TECHNICAL INFORMATION

SUBJECT: Auto-oiler puller and Auto-oiler installer

Number: Y2019-665
Issued: Apr. 30, 2019

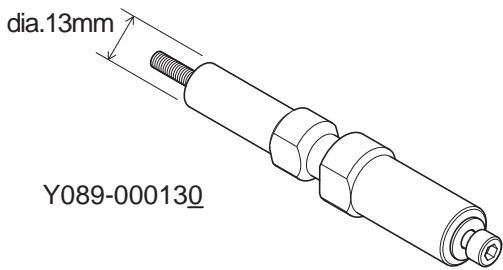
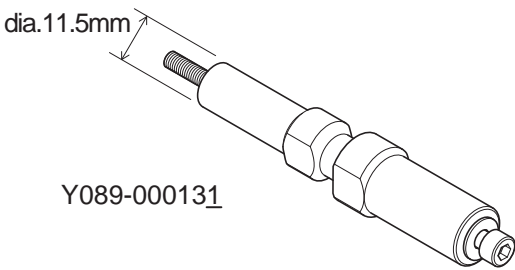
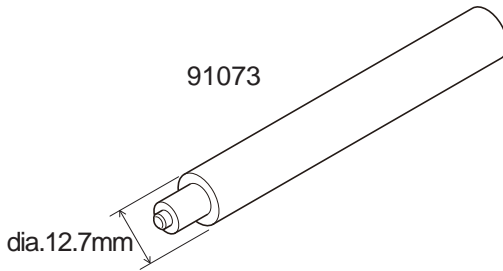
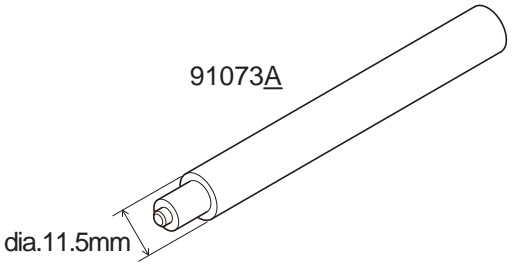
Introduced slim auto-oiler tool.

After this change, the auto-oiler of ECHO DCS-1600 can be removed and installed with these tools.

Before change	After change
Auto-oiler puller	 <p>Y089-000130</p>	 <p>Y089-000131</p>
Auto-oiler installer	 <p>91073</p>	 <p>91073A</p>
<p>Auto-oiler puller Y089-000130 can be replaced with Y089-000131. Auto-oiler installer 91073 can be replaced with 91073A.</p>
